MEMORANDUM

REVIEW TYPE: Preliminary Plan Review

PROJECT NAME: Montgomery Auto Sales Park

CASE #: 120041060 (1-04106)

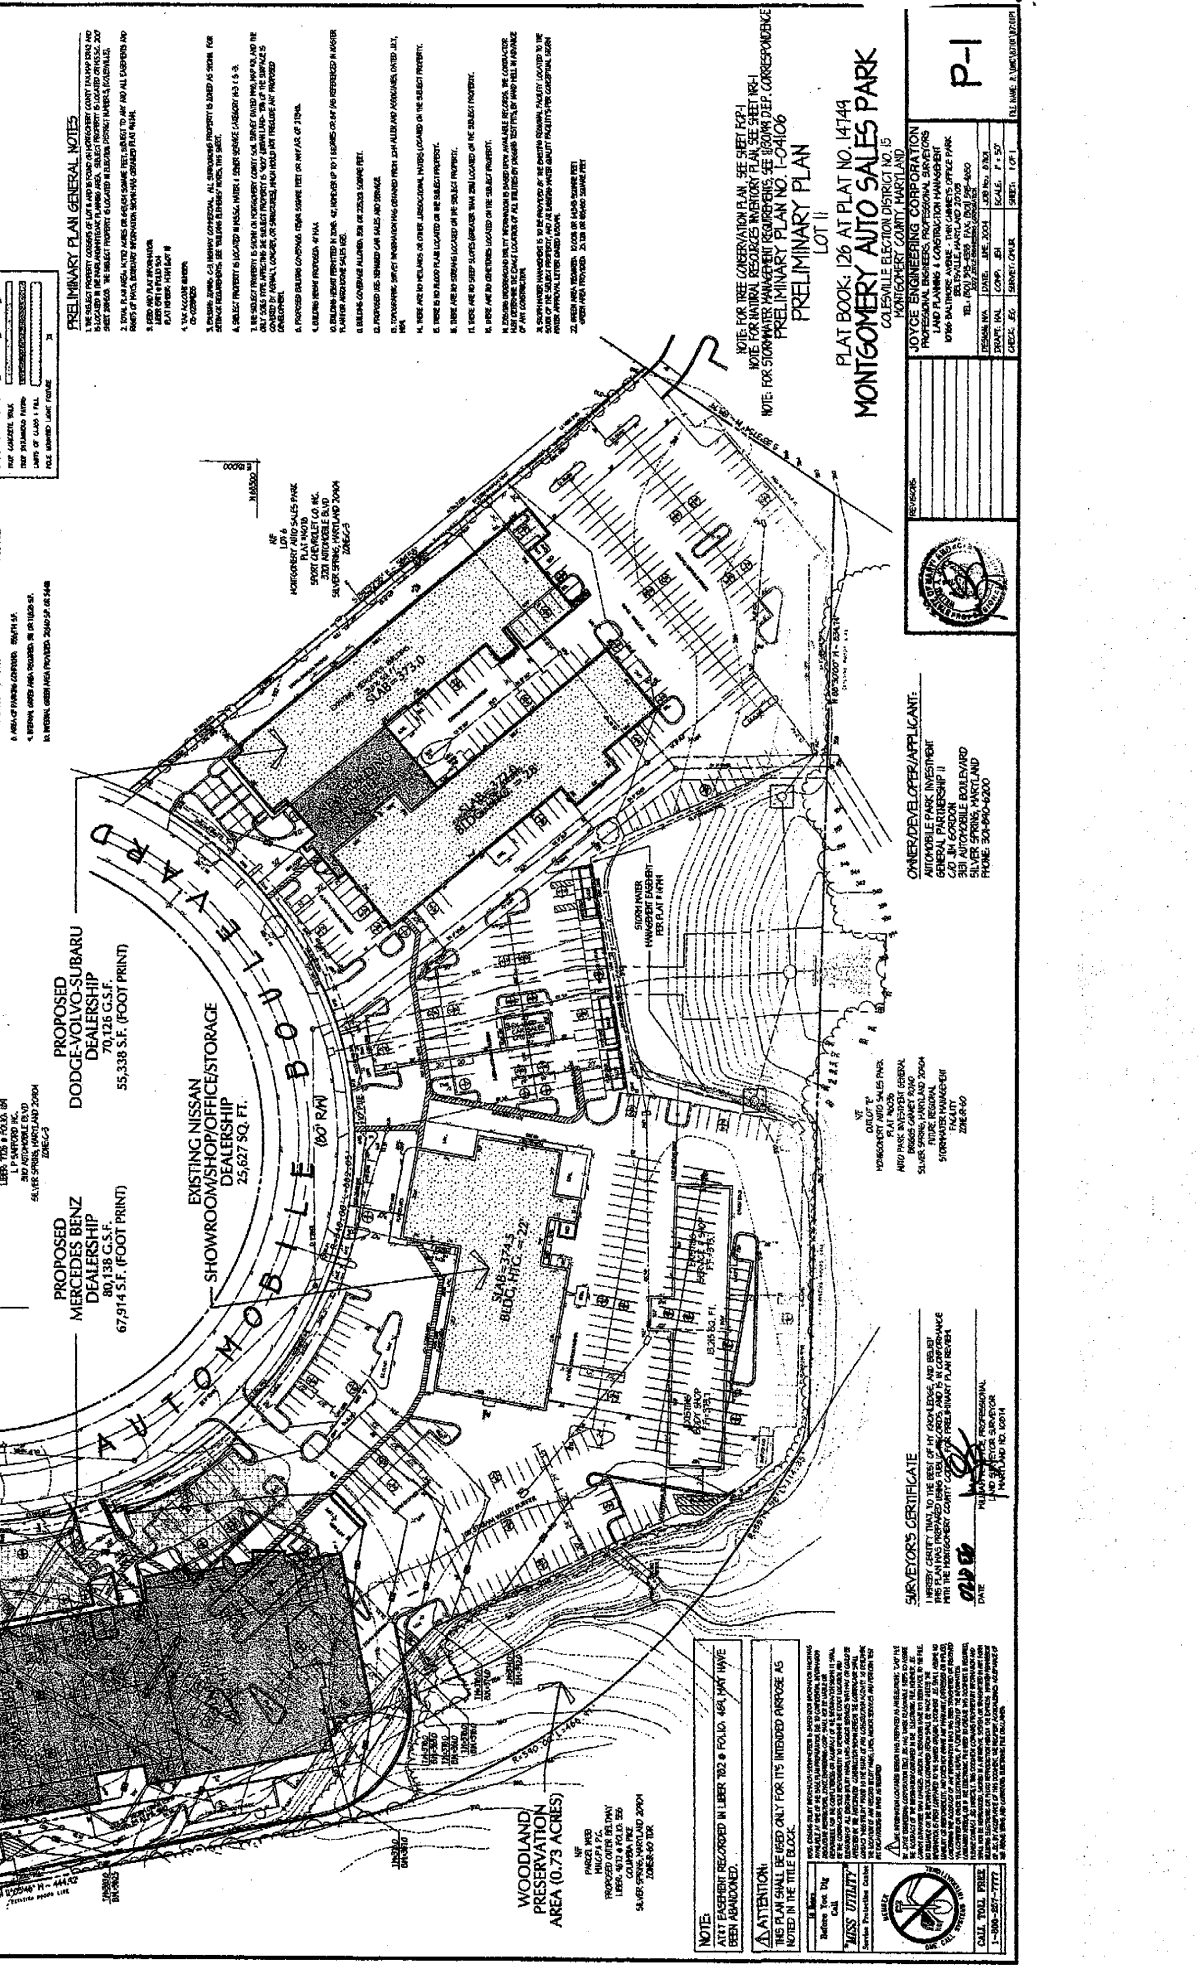
1. Our plan shows the proposed "Mercedes Benz dealership" structure will be in conflict with the existing 20 foot wide storm drain easement (recorded in Plat Book no. 84 at Plat no. 9610). The applicant's proposal to relocate the section of the conflicting system (under DPS permit) is hereby accepted. The record plat will need to reflect the adjustment to the easement limits.

CORRIDOR 1
CHECK IMPACTS TO
MONTGOMERY AUTO
SALES PARK REDEVELOPMENT

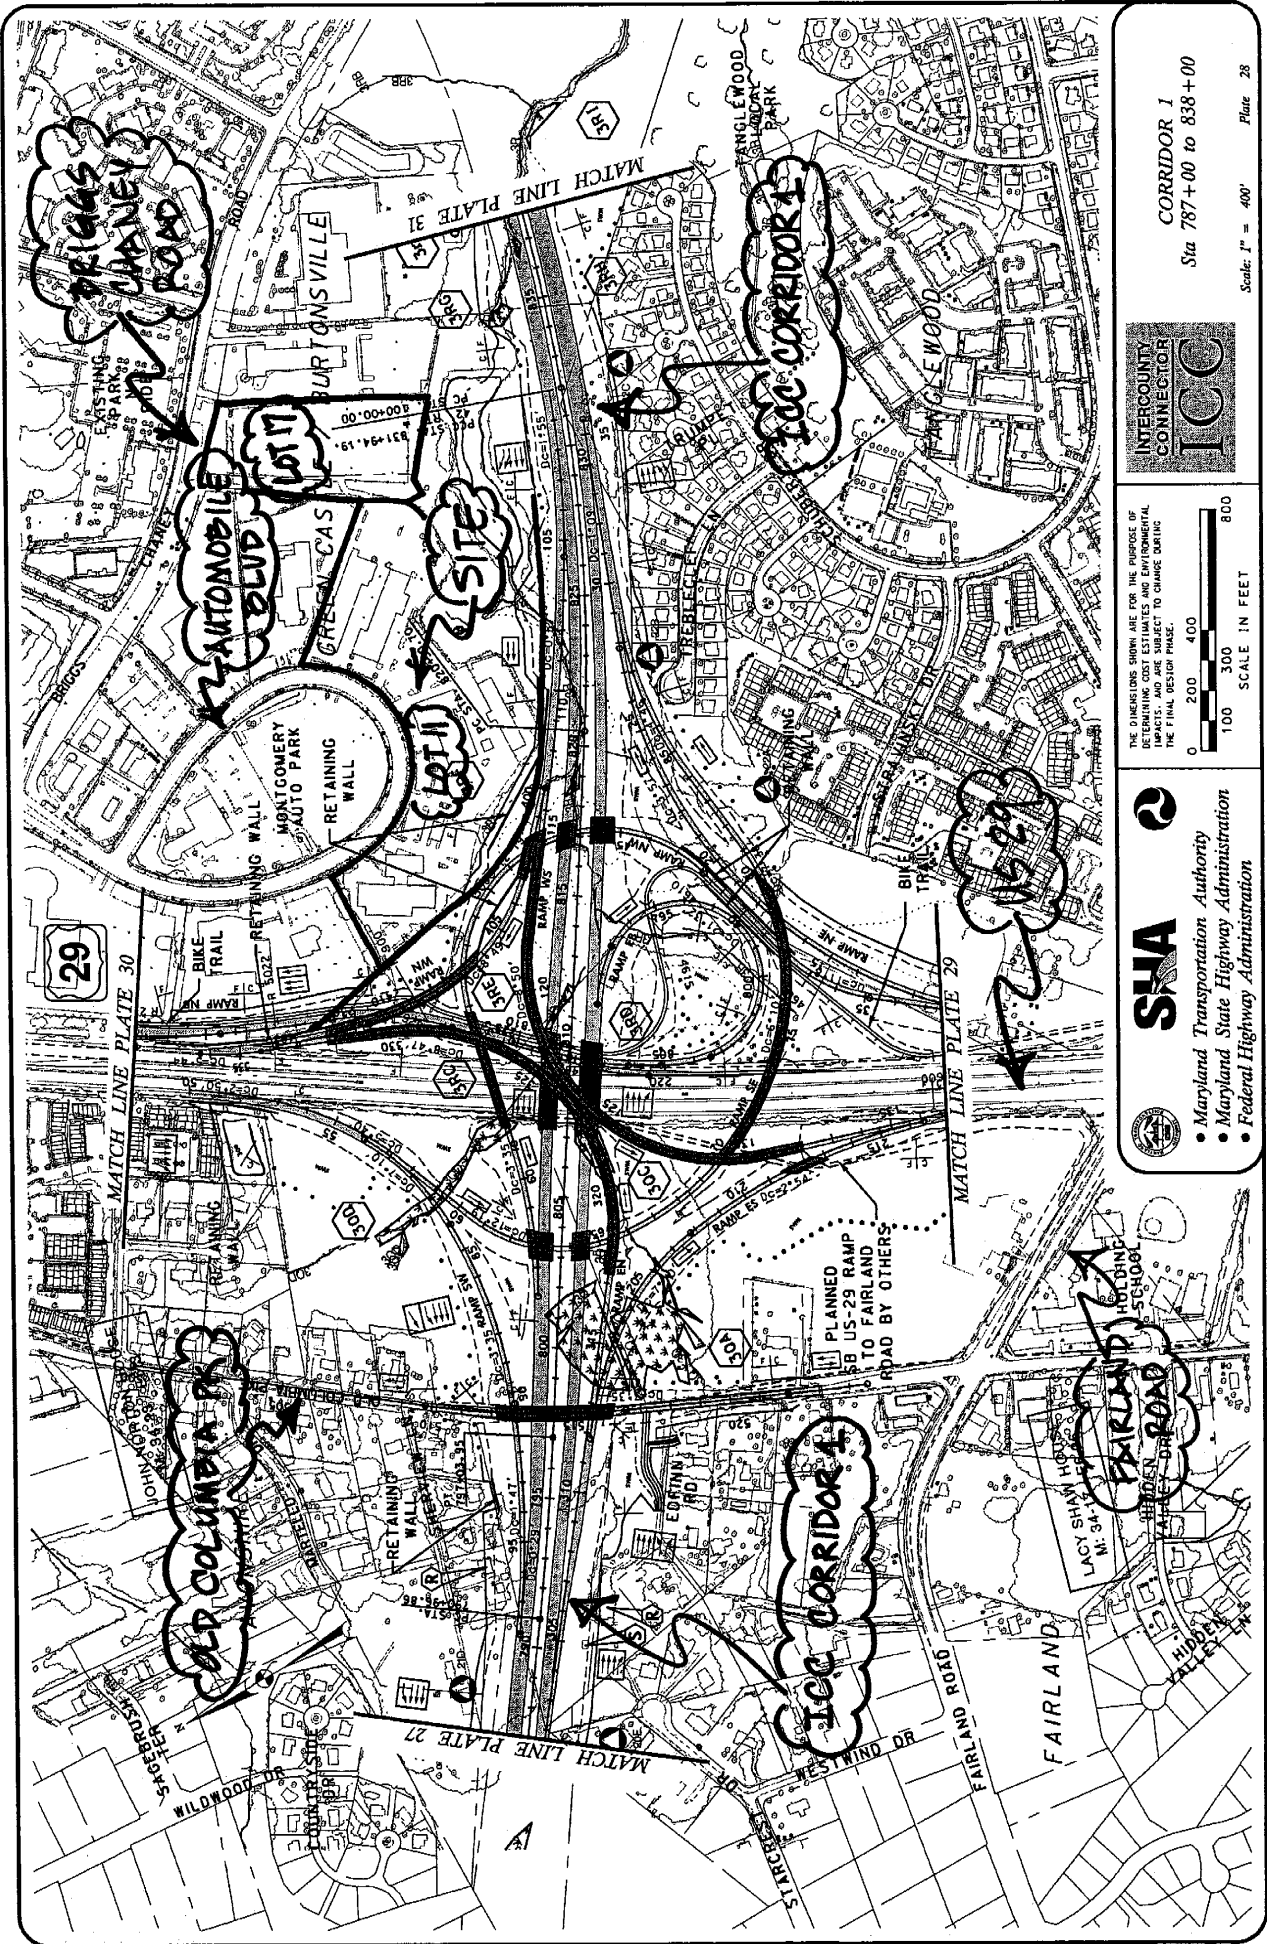
To protect property that will support the State Highway Administration/Maryland Transportation Authority (SHA/MdTA) locally preferred alternative, Corridor One, which is being studied as part of the current National Environmental Policy Act process for the project, we request that your agency require reservation of this property through the project's Record of Decision scheduled for release on April 1, 2006. In addition, we request that the Site Plan approval be made contingent upon the owner continuing to work with the SHA regarding grading and drainage to make certain that neither the owner's or SHA's interests are precluded by the other.
